PLAT COMMITTEE October 8, 2025

Case Number: 2025-PLT-062

Request: Approval of a Subdivision Plat, to be known as Replat of 13A and 13B of

Rural Street Villas, Section 2, dividing 0.093-acre into two single-family

2024PLT028; Proposed Plat

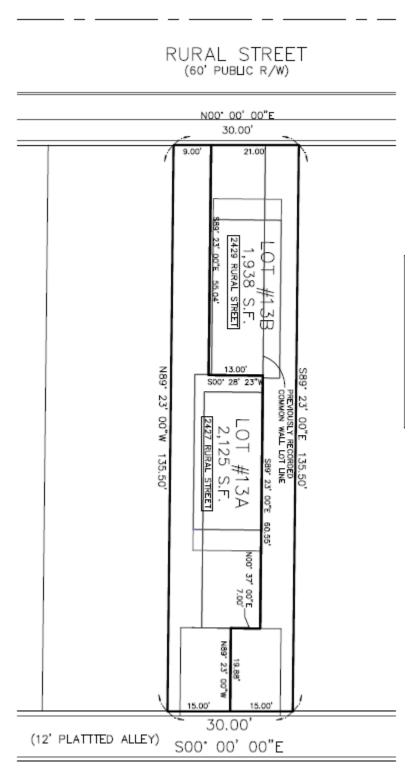
This proposed plat would amend the previous plat to create two (2) new lots with widths of nine (9) feet and 21 feet per the below exhibit (new Lot 13A and 13B). The proposed plat would meet the standards of the D-5 zoning classification for two-family dwellings except for deficient lot widths which are allowed per approval of 2024-DV2-024 and would still be applicable for the proposed plat.

Staff recommends that the Plat Committee **approve** and find that the plat, file-dated August 20, 2025, complies with the standards of the Subdivision regulations, subject to the following conditions:
